UNITED STATES PATENT AND TRADEMARK OFFICE

10/528,207

Harald Hagen

Office Action Summary

(marked Kim Figure 4)

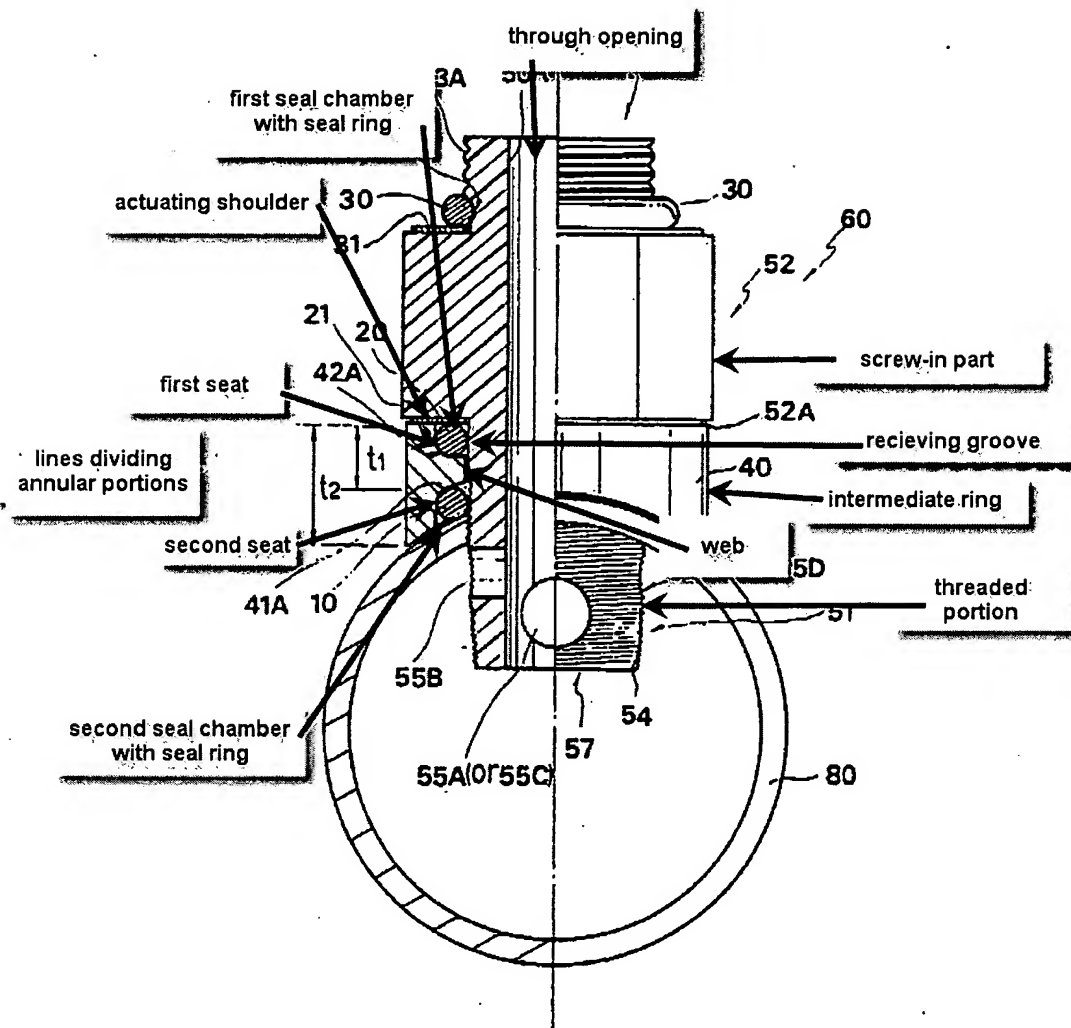
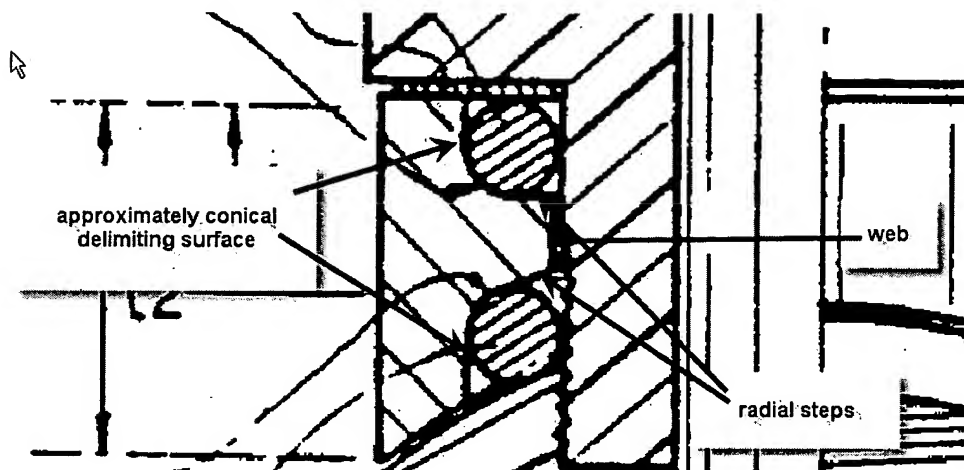
21. In regard to claim 1, Kim, in Figure 4 below, discloses an intermediate ring (part 40) for a screw-in part (part 52) of a fluid plug-in system, the screw-in part having a through-opening (as observed in marked Figure 4 below), an externally threaded portion (part 54) for screwing into a threaded bore of a base part, an actuating shoulder (as observed in marked Figure 4 below), and a receiving groove (as observed in marked Figure 4 below and as part 56, a smooth surface above

the threaded portion in Figure 2A), formed in the transition between the actuating shoulder and the externally threaded portion with a sealing ring comprising the intermediate ring adapted to be fitted onto the externally threaded portion (as observed in Figure 4 below) and having first and second axially opposite annular portions (as observed in marked Figure 4 below), the first annular portion, having on a side facing the actuating shoulder, a first seat (part 42A), which, together with the receiving groove and the actuating shoulder, forms a first seal chamber (as observed in Figure 4 below) for the first sealing ring, and the second annular portion having a second seat (part 41A) for a second sealing ring such that, when the screw-in part is screwed into the threaded bore having a surrounding surface adjacent on the mouth side, a second seal chamber (as observed in Figure 4 below) for the second sealing ring is formed between the second seat, the surrounding surface and the externally threaded portion.

23. In regard to claim 3, Kim discloses that the intermediate ring first and second annular portions are separated by an internal radial annular web (as observed in marked Figure 4 below), which divides the first and second seats from one another.

24. In regard to claim 4, Kim discloses the intermediate ring sealing ring seats formed by a radial step surface and an approximately conically widening delimiting surface adjacent to it on the outside (as observed in marked cut-out of Figure 4 below).

26. In regard to claim 6, the Figure 4 cross-hatching indicates the material is metal. Note, it is the patentability of the product, and not recited process steps, that is to be determined and thus how the intermediate ring was formed is of little consequence to the patentability determination of the final product. Kim possesses an intermediate ring that meets the structure of the claim.

(marked Neuschotz Figure 4)

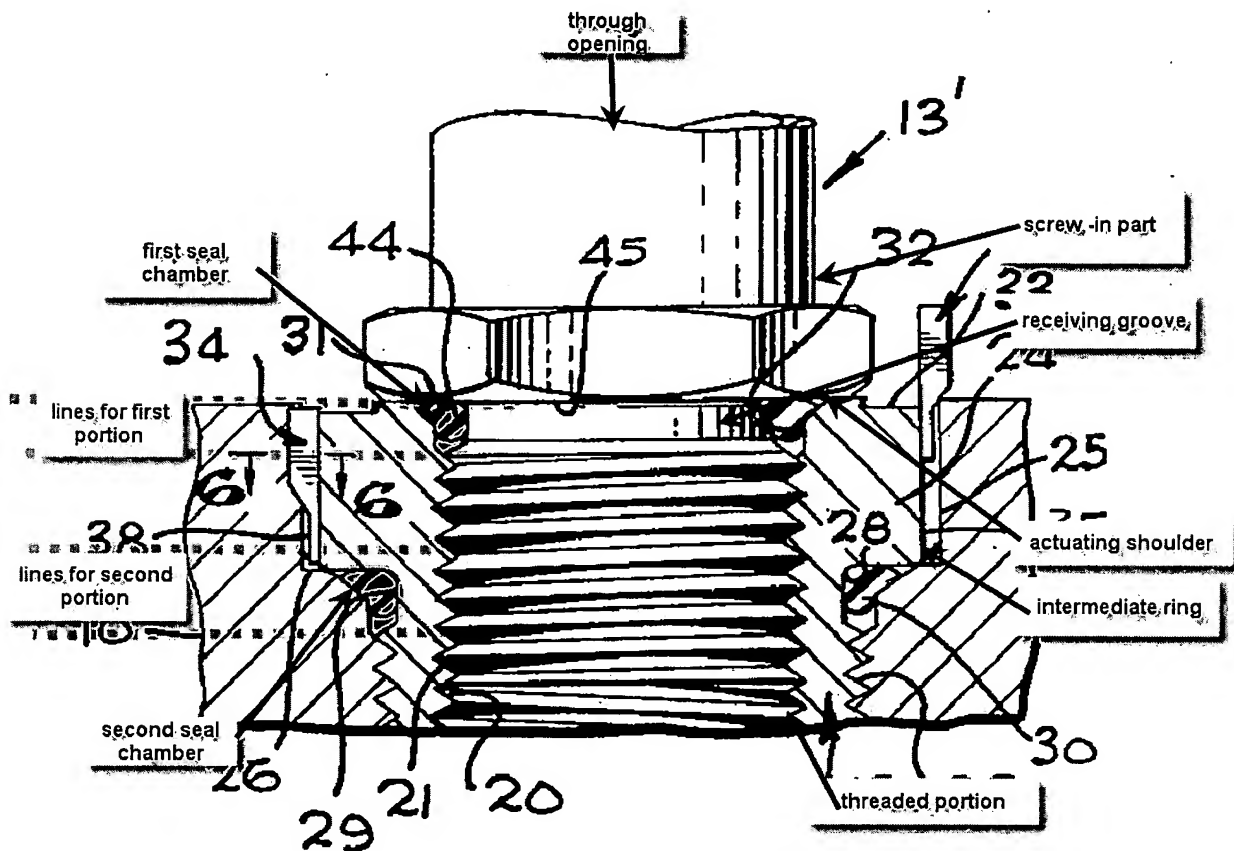
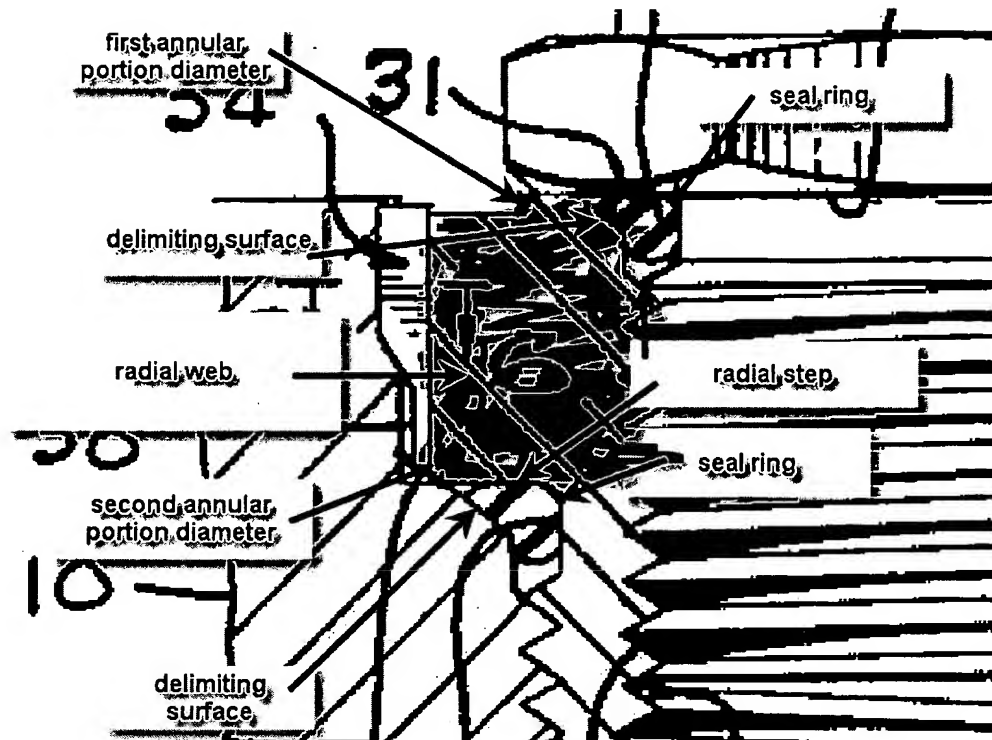
28. In regard to claim 1, Neuschotz, in Figure 4 below, discloses an intermediate ring (as observed in marked Figure 4 below) for a screw-in part (as observed in marked Figure 4 below) of a fluid plug-in system, the screw-in part having a through-opening (as observed in marked Figure 4 below), an externally threaded portion (as observed in marked Figure 4 below) for screwing into a threaded bore of a base part, an actuating shoulder (as observed in marked Figure 4 below), and a receiving groove (as observed in marked Figure 4 below), formed in the transition between the actuating shoulder and the externally threaded portion with a sealing ring comprising the intermediate ring adapted to be fitted onto the externally threaded portion (as observed in Figure 4 below, the intermediate ring is on the threaded portion of the screw-in part) and having first and second axially opposite annular portions (lines added to marked Figure 4 below to emphasize the portions), the first annular portion, having on a side facing the actuating shoulder, a first seat (part 31), which, together with the receiving groove and the actuating

shoulder, forms a first seal chamber (as observed in Figure 4 below) for the first sealing ring, and the second annular portion having a second seat (part 28) for a second sealing ring such that, when the screw-in part is screwed into the threaded bore having a surrounding surface adjacent on the mouth side, a second seal chamber (as observed in Figure 4 below) for the second sealing ring is formed between the second seat, the surrounding surface and the externally threaded portion.

29. In regard to claim 2, Neuschotz discloses intermediate ring further comprising two sealing ring seats and the associated sealing rings are formed such that, in a mounted state, compression of the first and second sealing rings (as observed in marked cut-out of Figure 4) is achieved and in this connection the second sealing ring is compressed mainly axially essentially without radial deformation acting against the externally threaded portion (as can be observed in marked cut-out of Figure 4, the second seal ring does not contact the threads).

30. In regard to claim 3, Neuschotz discloses that the first and the second annular portions are separated by an internal radial web (as observed in marked cut-out of Figure 4 below), which divides the first and second seats from one another.

31. In regard to claim 4, Neuschotz discloses the intermediate ring sealing ring seats formed by a radial step surface and an approximately conically widening delimiting surface adjacent to it on the outside (as observed in marked cut-out of Figure 4 below).

32. In regard to claim 6, Neuschotz discloses that the first annular portion is designed to be smaller in diameter than the second annular portion (as observed in marked cut-out of Figure 4).

(marked Hagen et al Figure 8)

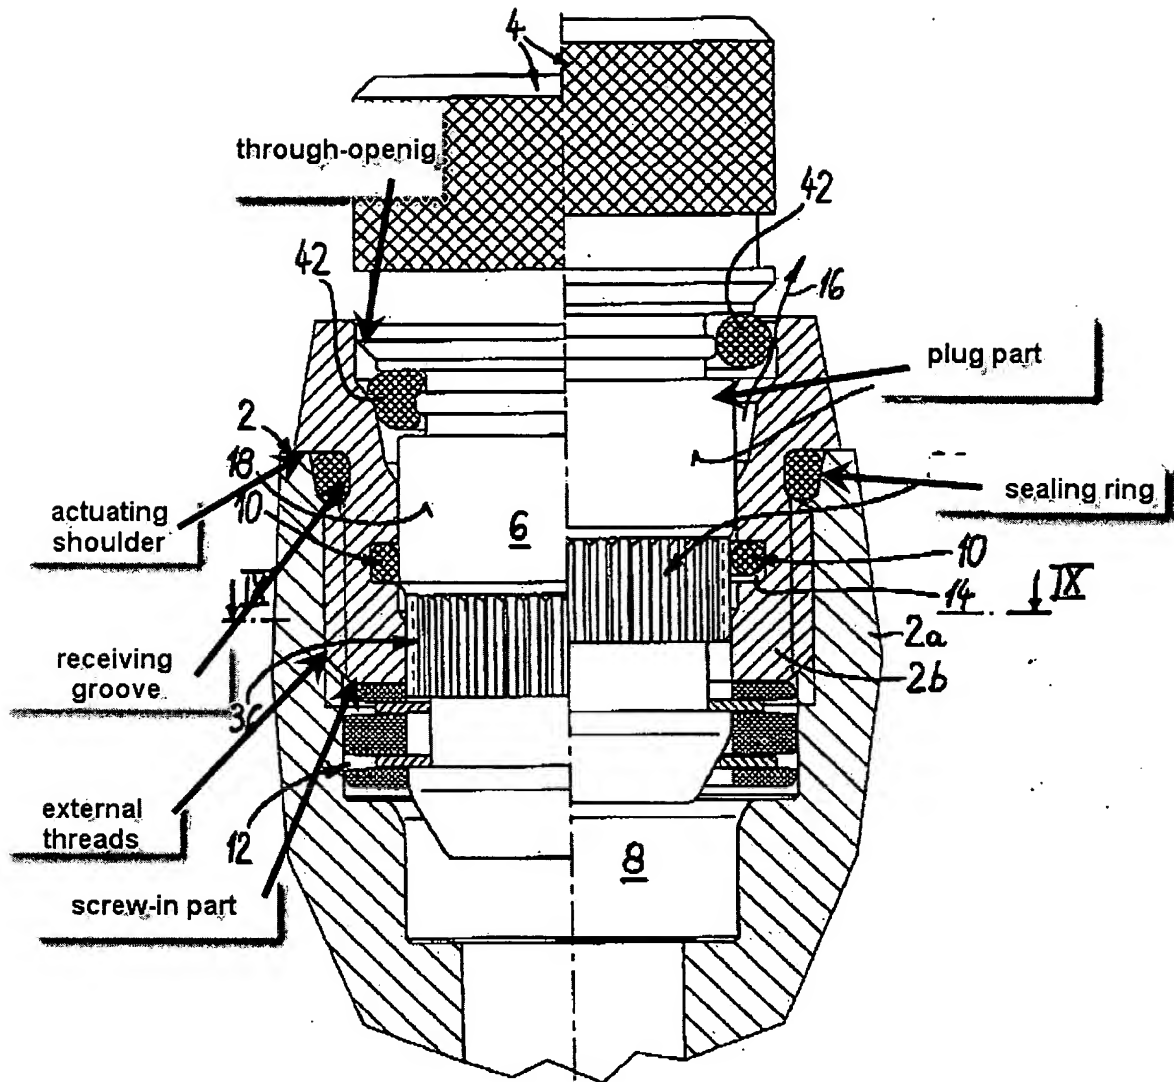
36. In regard to claim 1, Hagen et al, in Figure 8 below, disclose the claimed invention except for the sealing ring comprising an intermediate ring having a first and a second axially opposite annular portions, the first annular portion having on a side facing the actuating shoulder, a first seat, which, together with the receiving groove and the actuating shoulder, forms a first seal chamber for the first sealing ring, and the second annular portion having a second seat for a second sealing ring such that, when the screw-in part is screwed into the threaded bore having a surrounding surface adjacent on the mouth side, a second seal chamber for the second sealing ring is formed between the second seat, the surrounding surface and the externally threaded portion. Creamer, in Figure 5 below, teaches a sealing ring with an intermediate ring to allow a screw-in part to be radially orientated in a base part (column 1, lines 53-58). It would have been obvious to one of ordinary skill in the art at the time the invention was made to provide the screw-in part of Hagen et al with the sealing ring as taught by Creamer to allow radial orientation of the screw-in part in the base part.

(marked Creamer Figure 5)

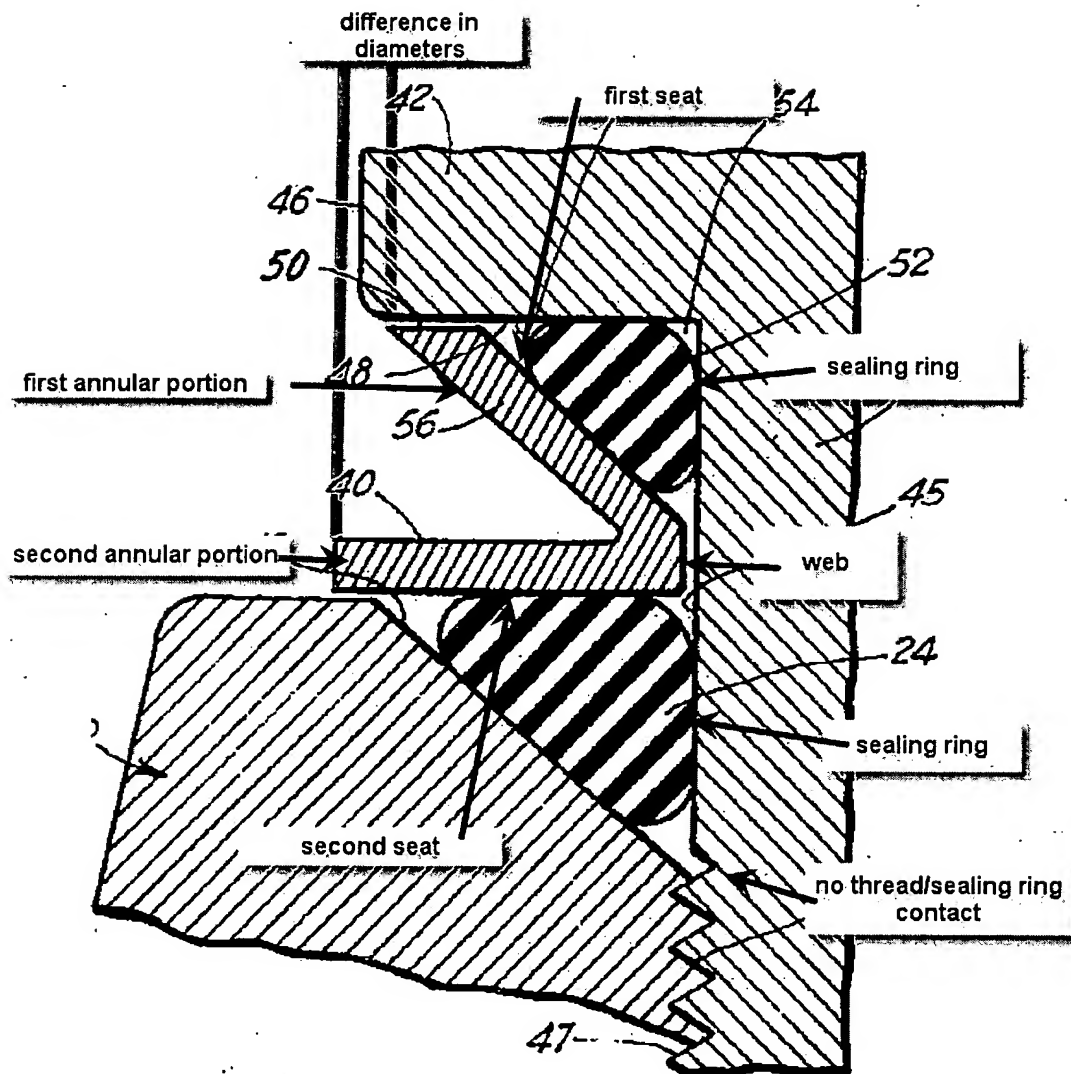
40. In regard to claim 6, Creamer further teaches that his intermediate ring has a first annular portion smaller in diameter than the second annular portion (as observed in marked Figure 5 below).
